March 19, 2024

**Re: *Submission of Revised Materials for Draft Plan of Subdivision
Response to Comments – Planning/Urban Design Response
City File No. 25T – 202305
75 Centennial Parkway North, Hamilton***

Figure 1: Transit Circulation Diagram. Source: Figure 9-2 from March 2024 LEA Transportation Impact Study.

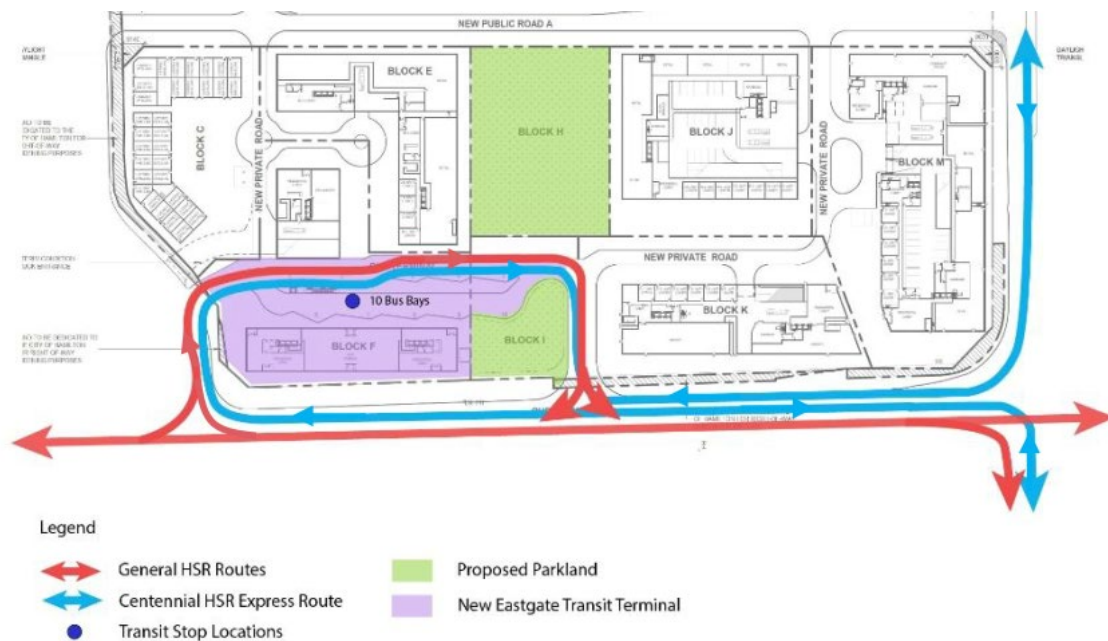
Comments from HSR staff were received on November 15, 2023, and additional comments were received on December 11, 2023.

The comments from HSR were primarily concerned with:

- bus routing throughout the internal private road network;
- bus ingress and egress to the proposed HSR terminal being forward motion-only;
- the interface with future LRT operations on Queenston Road;
- the number of bus bays provided (HSR requested at least 6 bays for standard buses, and an additional 2 for accordion buses, for a total of 8 bus bays);
- pedestrian safety and crosswalks, signage and signaling, and customer shelter and weather protection for outdoor bus bays.

In addition to the November and December 2023 written comments, verbal comments were provided from HSR staff that 10-12 bus bays could potentially be required in the future to accommodate expected growth in bus service.

In response to comments received, the concept plan has been revised to include ten (10) bus bays within the proposed transit terminal including two (2) bays specifically designed to accommodate the articulated busses used for HSR’s express routes. Buses will travel in a forward-only motion (no reversing), entering via a driveway

connection to Kenora Avenue and exiting using the existing mall signalized access on Queenston Road.

The proposed express bus route has also been modified in response to HSR comments to enter the transit terminal using the proposed bus access off Kenora Avenue and exit directly onto Queenston Road, where they can then head east towards Centennial Parkway, eliminating the previous routing through the eastern portion of the subject site. as shown in **Figure 1** below (Figure 9-2 from the March 2024 LEA Transportation Impact Study). The station and proposed road network have been designed to accommodate all required bus movements at the intersections of Kenora Avenue and Queenston Road as well as the existing mid-block signalized intersection along Queenston Road.
